District of Chetwynd

RFQ – Airport Runway Lighting Replacement

Addendum 1

EDGE LIGHTING DETAIL (TAXI & APRON TURN OFF LIGHT UNITS) SCALE: N.T.S.

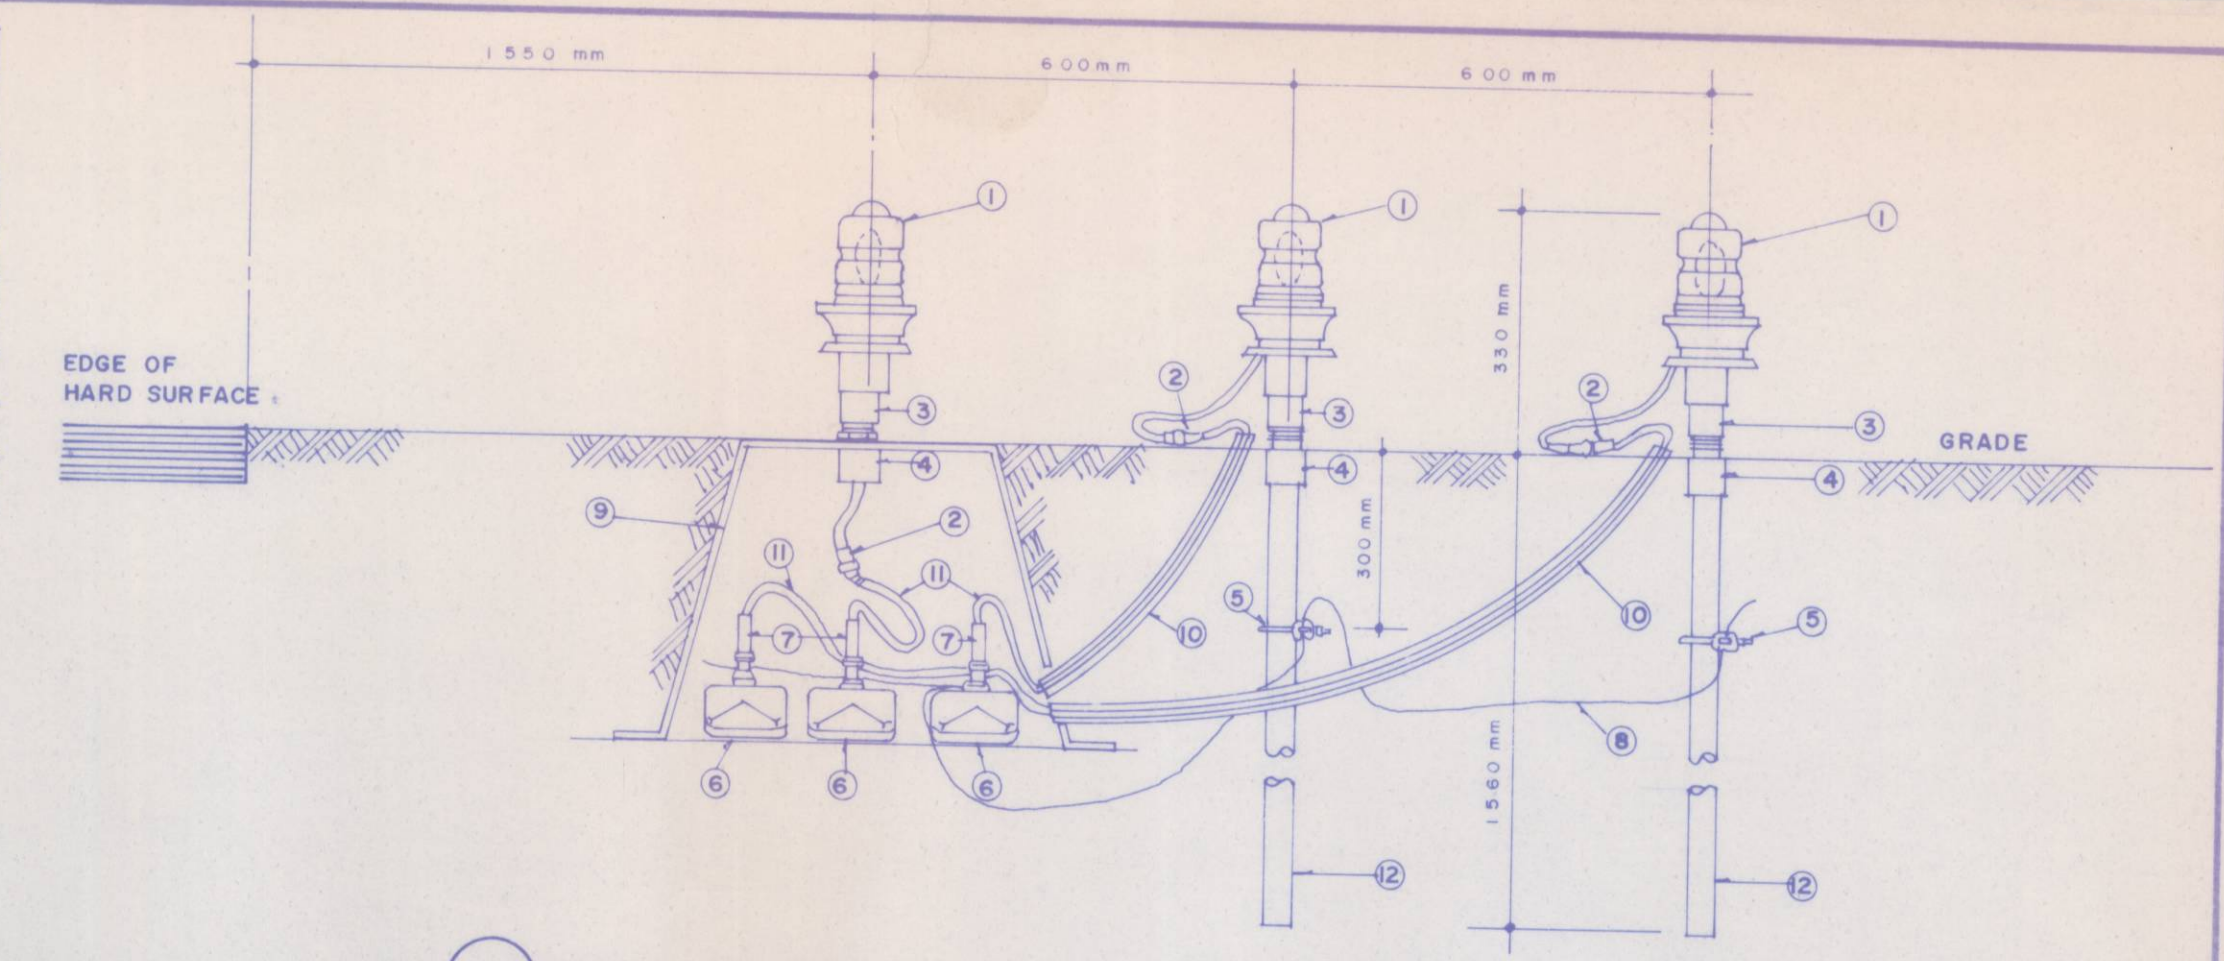
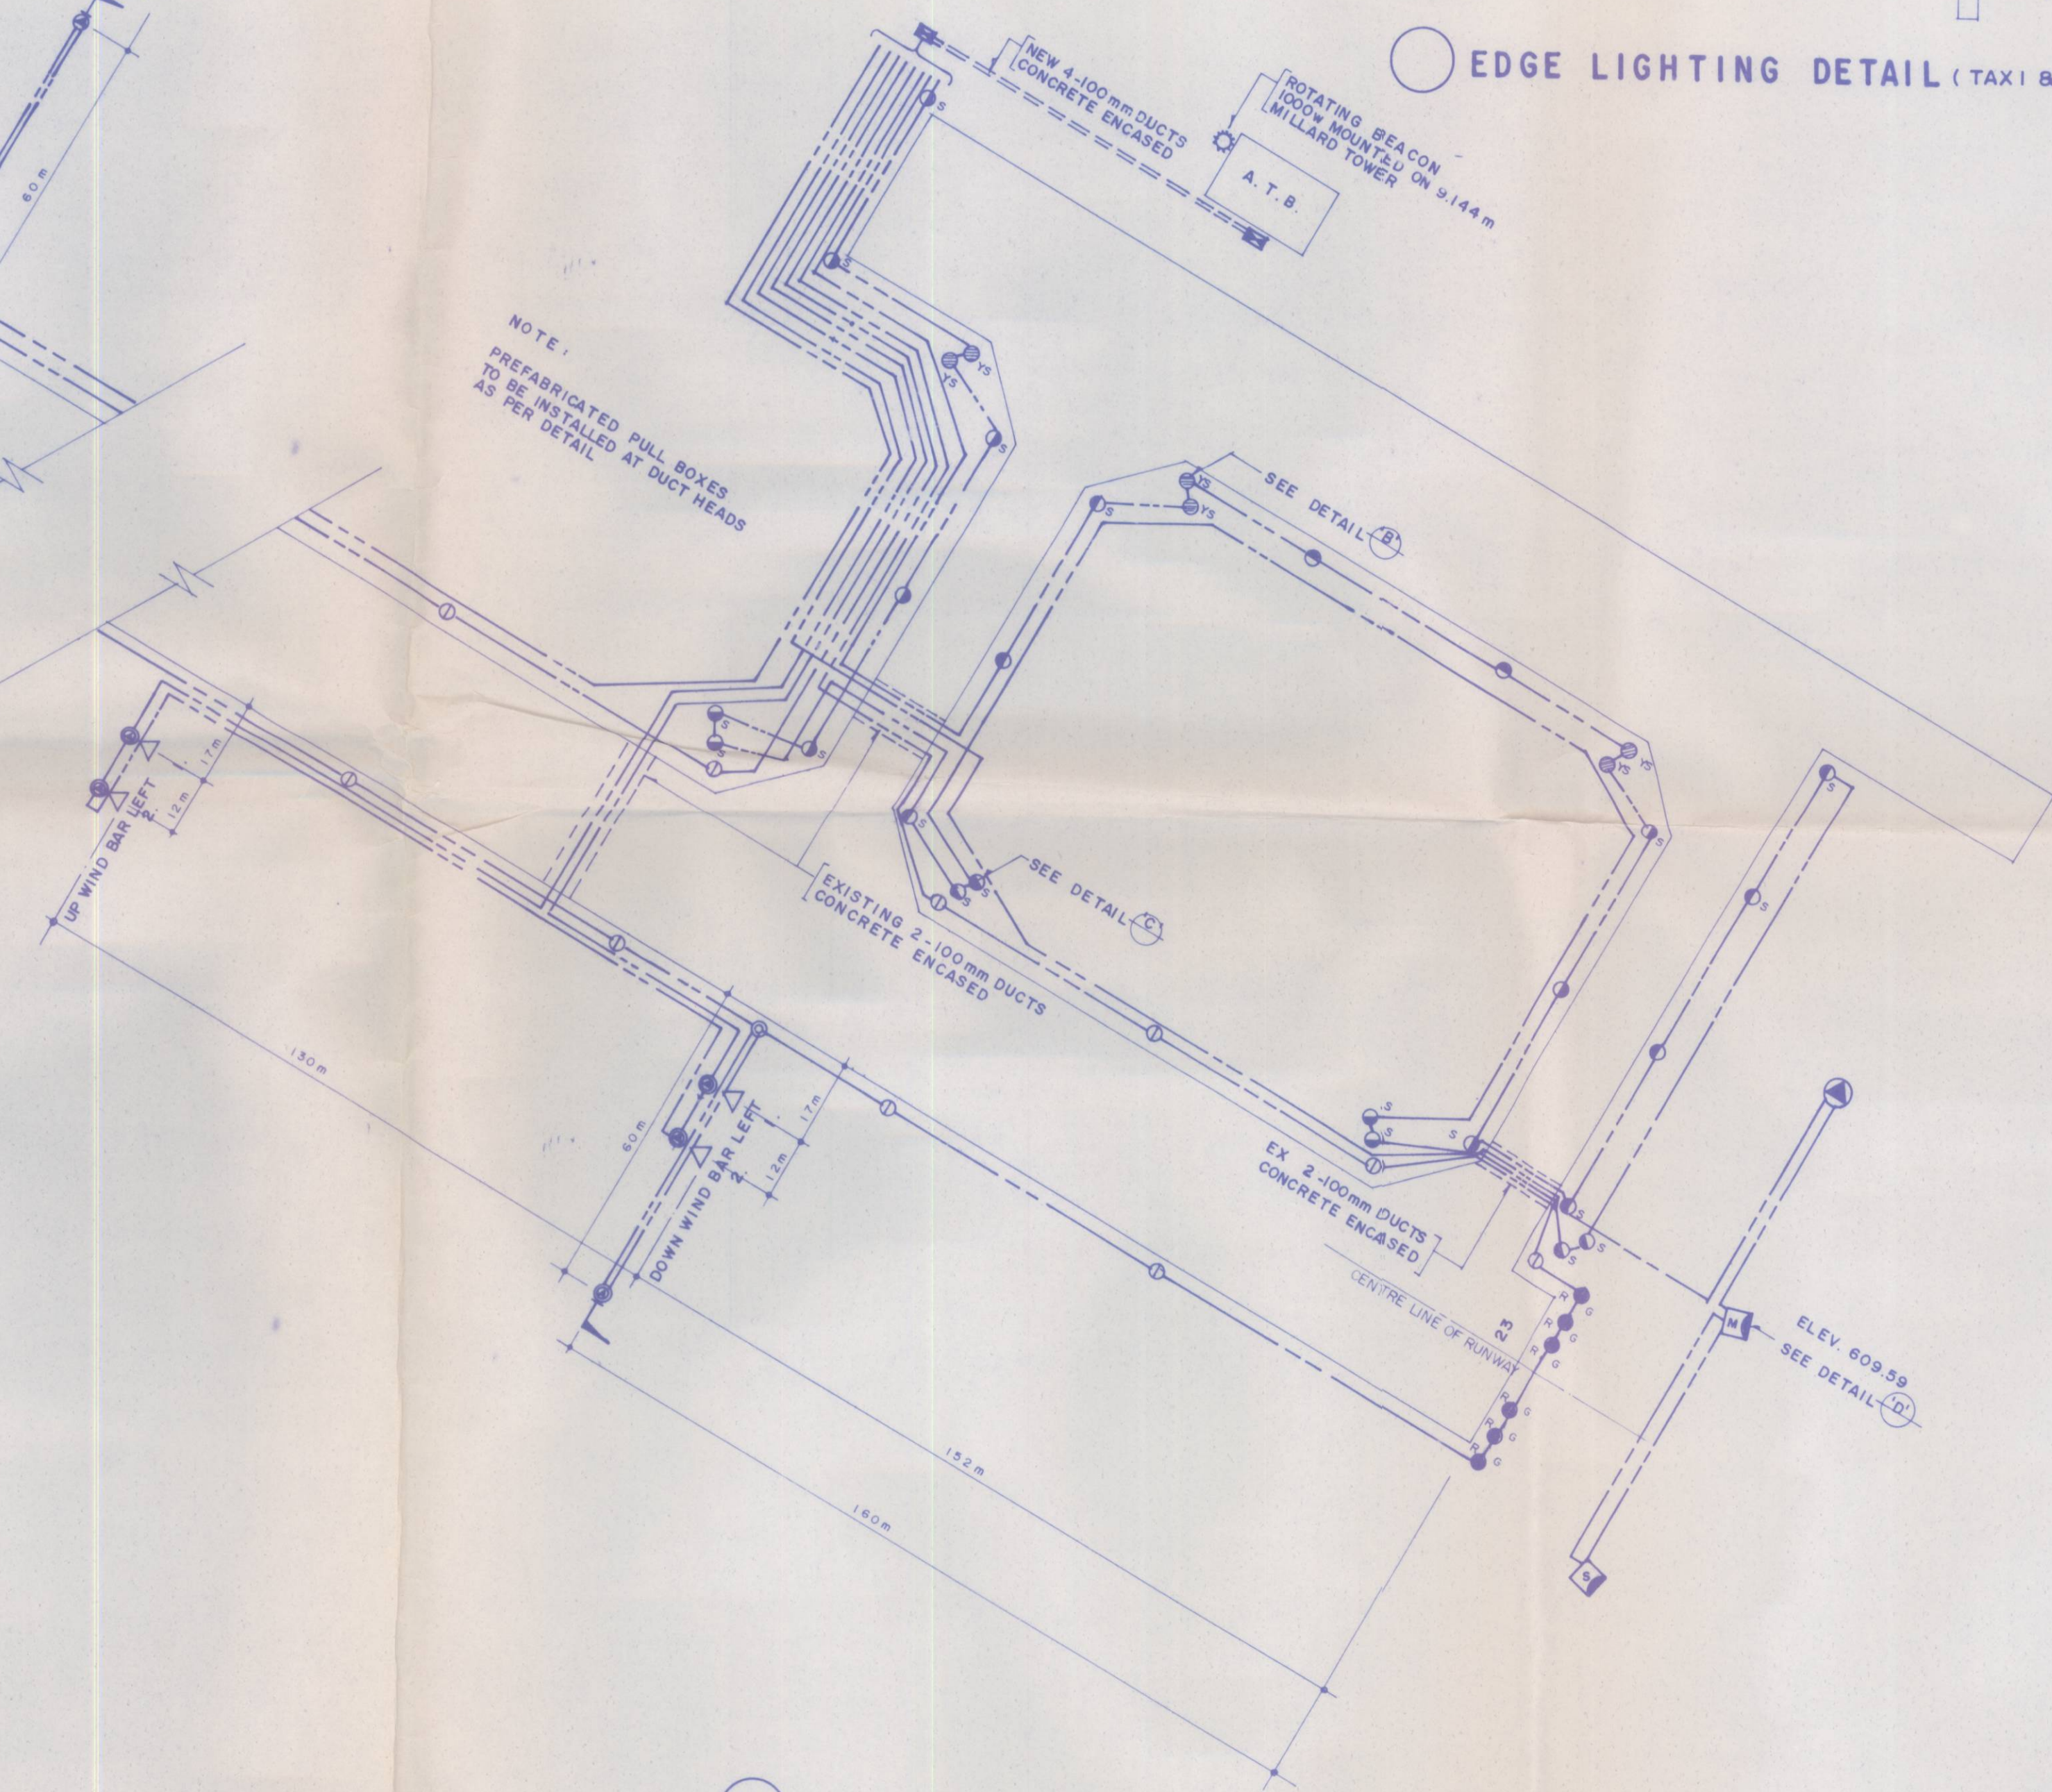
13. Please confirm the exact required fixture heights, mounting threads, colour/orientation combinations, arctic heaters (if required), frangible couplings, and transformer wattages. Precise technical requirements are needed to ensure the correct products are procured and installed.

The information we have available for mounting threads, fixture heights and frangible couplings may be found in the electrical drawings attached to this addendum. There are some inconsistencies between the installed height of the light in the field, and the as-built drawings. The District of Chetwynd will work with the successful bidder to determine a consistent installation height for stake mounted lights.
